Addendum Number Two
To The Drawings and Specifications for
Juvenile Services Building
RFB Bid Number: 26-0021, Sedgwick County, Kansas

Issued: October 23, 2026

HANNEY & ASSOCIATES ARCHITECTS
1726 South Hillside, Wichita, Kansas

NOTICE TO BIDDERS
You are hereby instructed to include in your bids the following changes and/or corrections to the Drawings and Specifications for the **Construction of the New Juvenile Services Building at 881 S. Minnesota, Wichita, Kansas 67211.**

SHEET
CODE 1

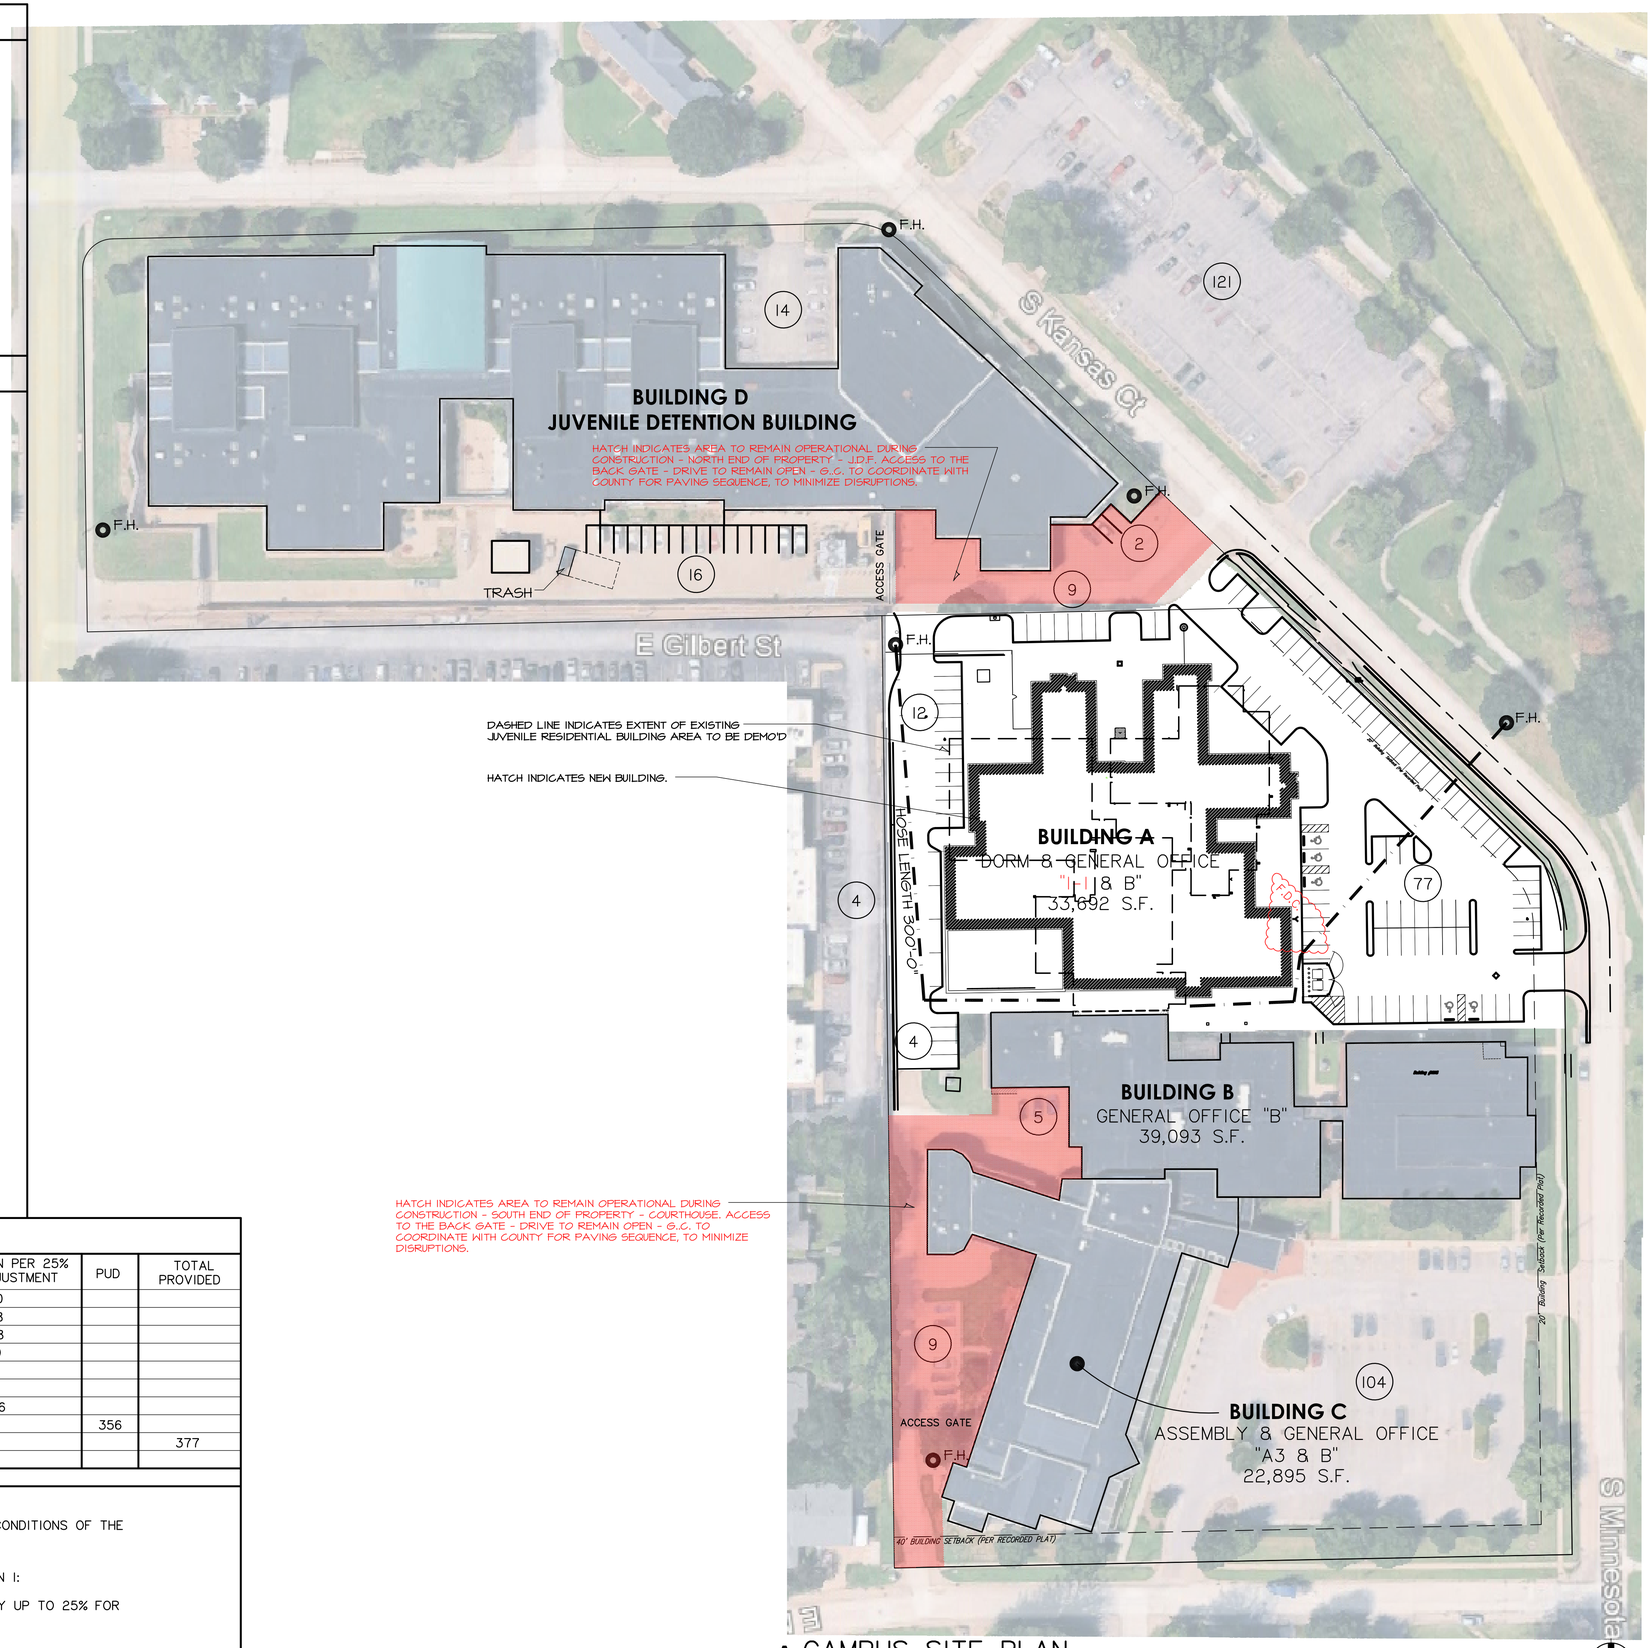
b. The existing delivery and drop-off area on the South side of the Juvenile Detention center is to remain open and available for use throughout the course of this project, this area is North of the project area – illustrated on CODE 1 – reissued with this addendum.

c. The South drive and portions of the parking area behind the existing Juvenile Courthouse are to remain open and accessible throughout the course of construction. This area is South of the project area – illustrated on CODE 1 – reissued with this addendum.

3.7 Sheet Code 1 - Code Site Plan:
Drawing re-issued to illustrate site circulation areas to remain open during construction.

11 CANOPY SECTION

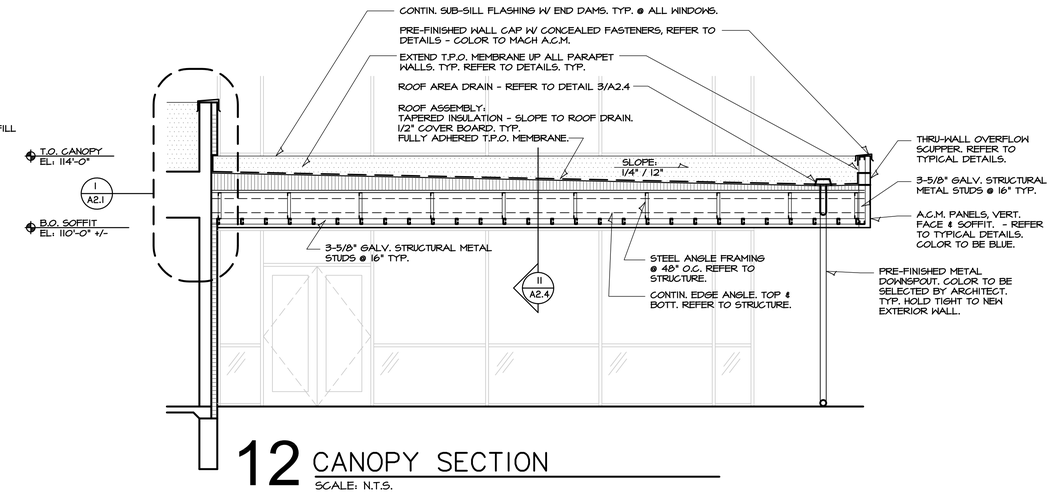
3.8 Sheet A2.1 - Lower Roof Plan:
Drawing re-issued to clarify entry canopy construction.

3.9 Sheet A2.4 - Roofing Details:
Details 11 & 12 added for clarification on entry canopy.

A AREA "E" ENLARGED REFLECTED CEILING PLAN - J.F.S.

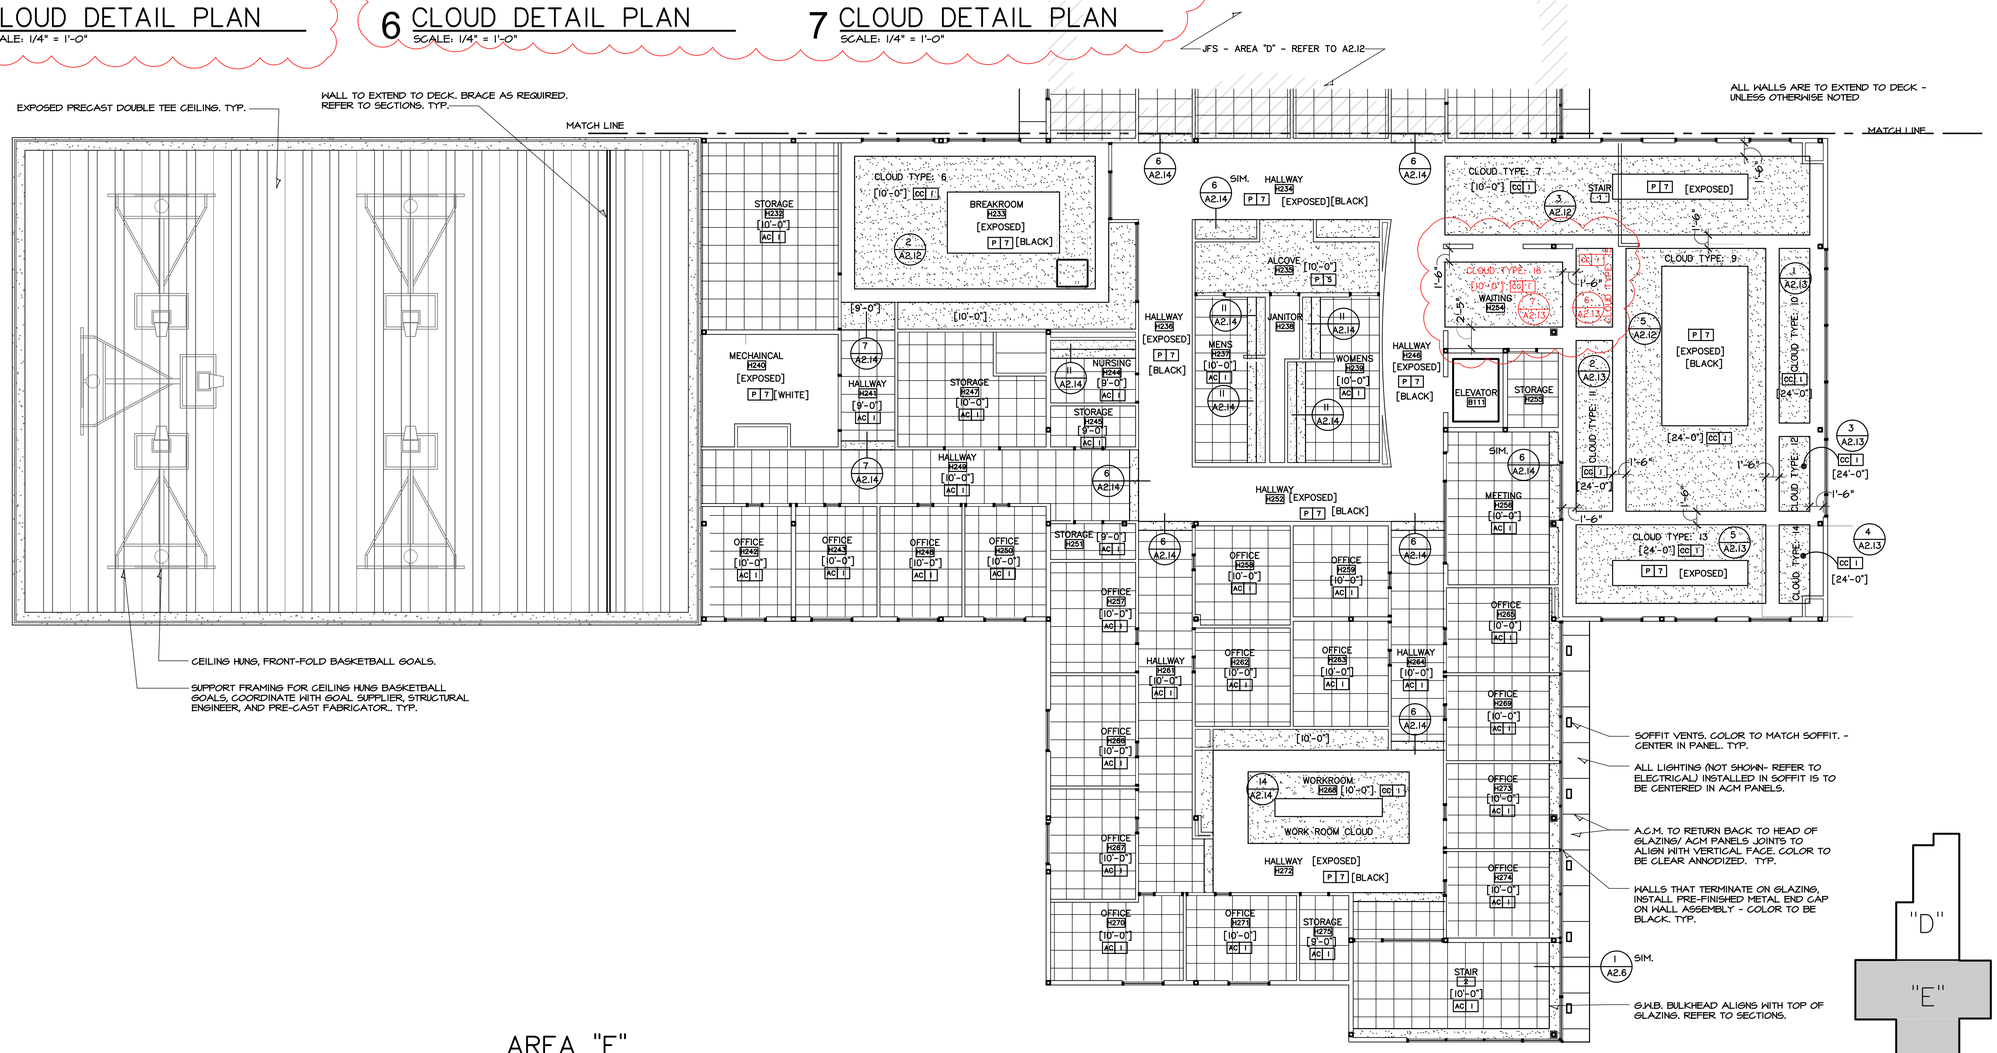
3.3 Sheet A2.13 – Area "E" Reflected Ceiling Plan
Ceiling clouds 15 & 16 have been added
Detail #5 has been revised to read "cloud type 13 – lobby"

A3.3

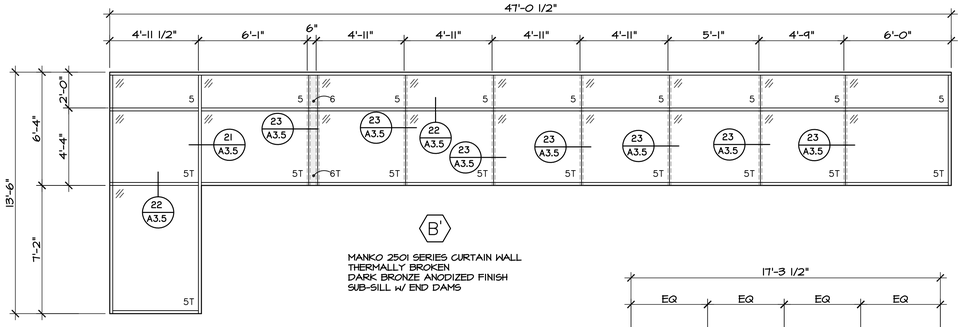
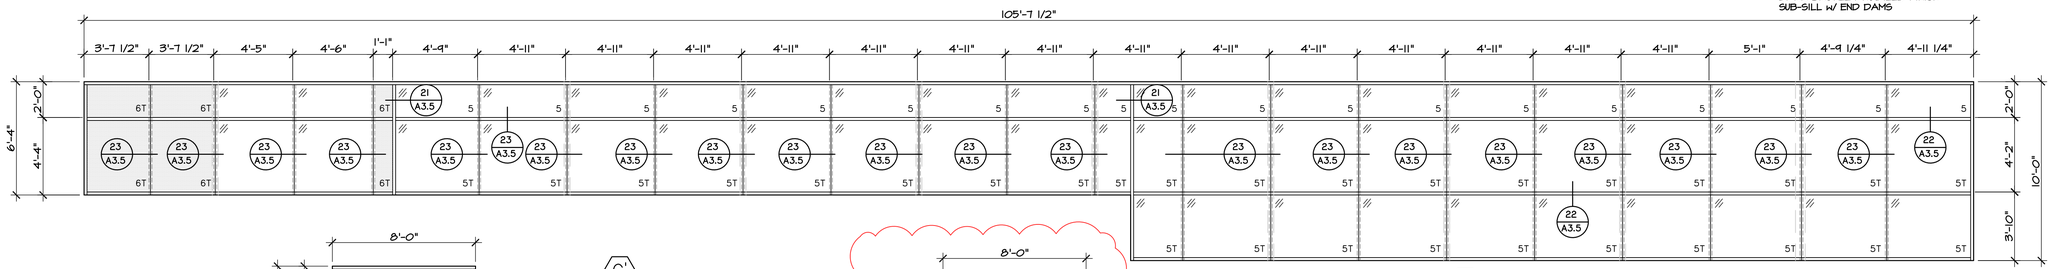
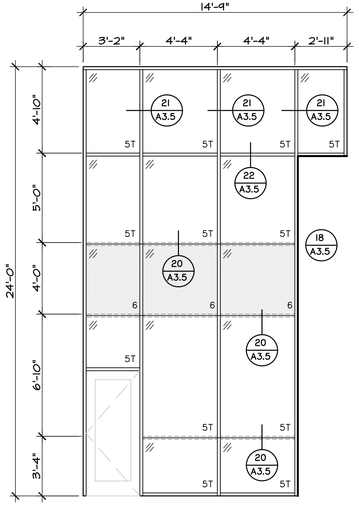
3.3 Sheet A3.3 - Window Types:
Window Types "R" & "K" have been revised

A6.2

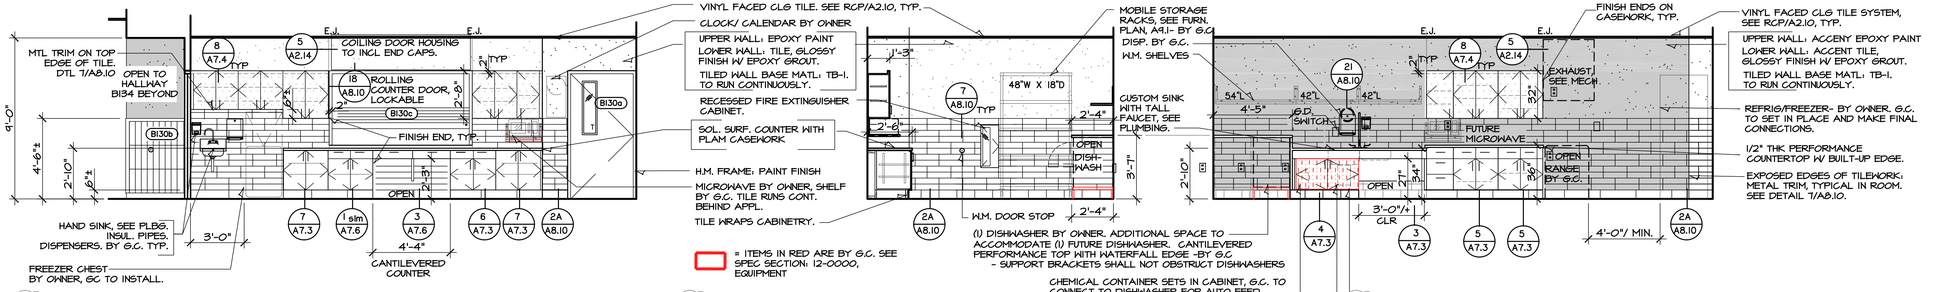
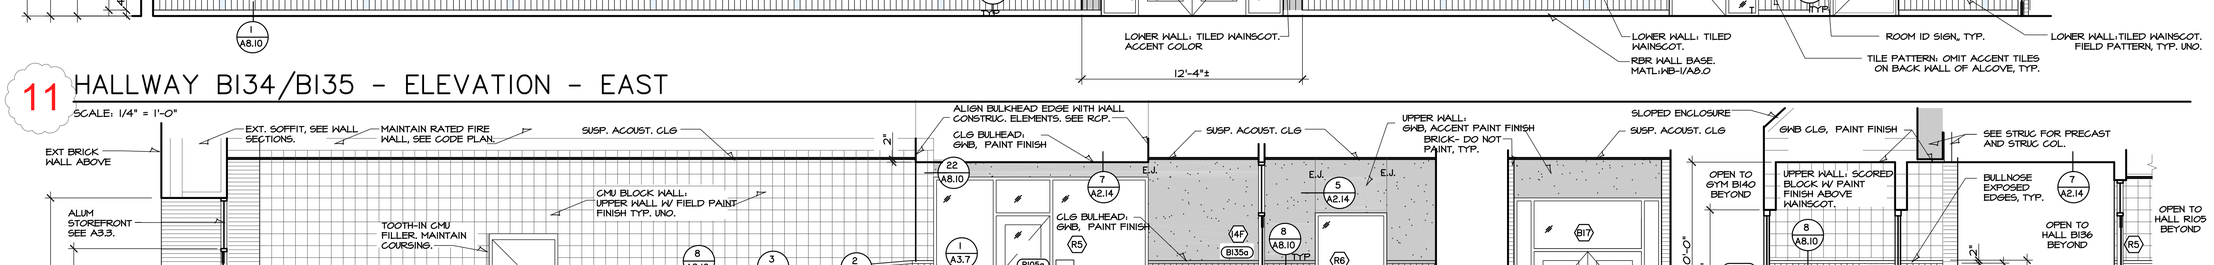
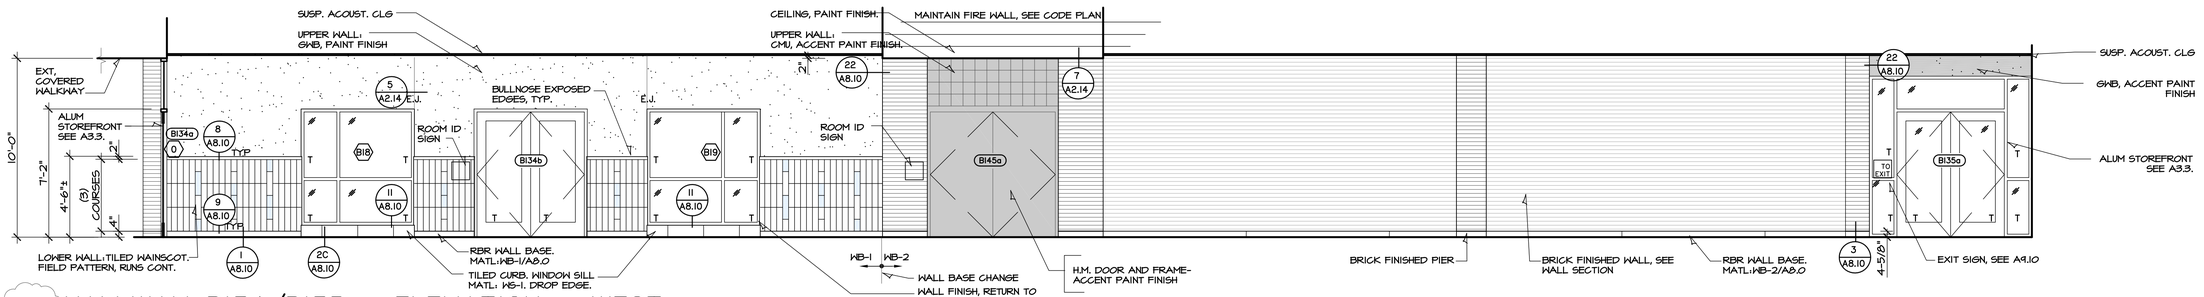
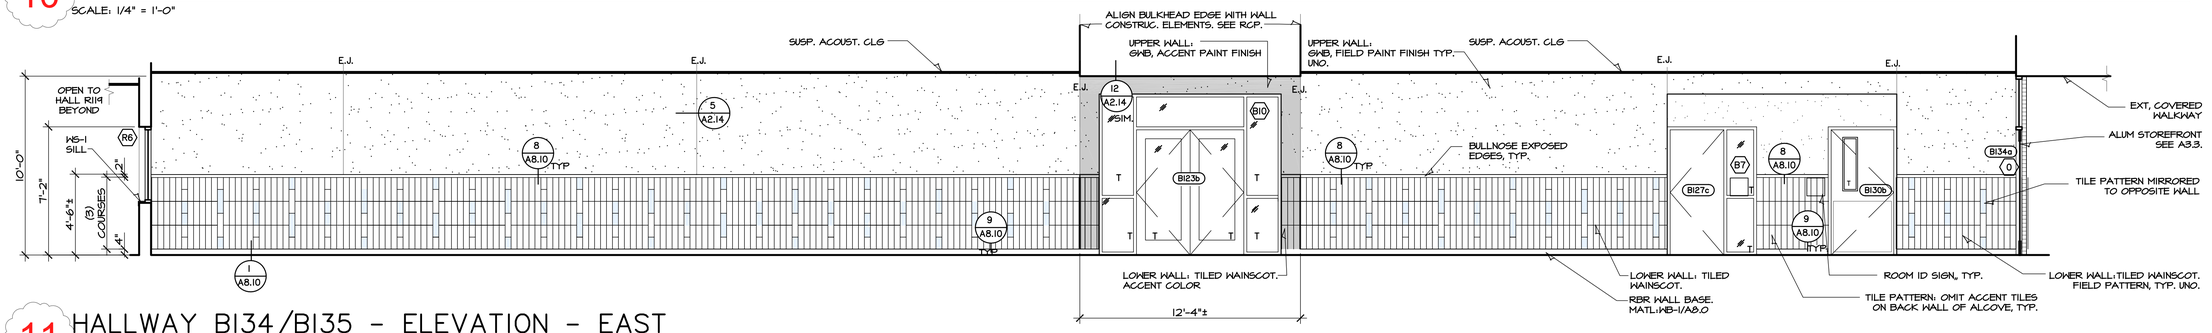
3.13 Sheet A6.2 - Interior Elevations:
Re-issued with this addendum. Revised interior elevations – 6,7,8,9, & Details A, B, C
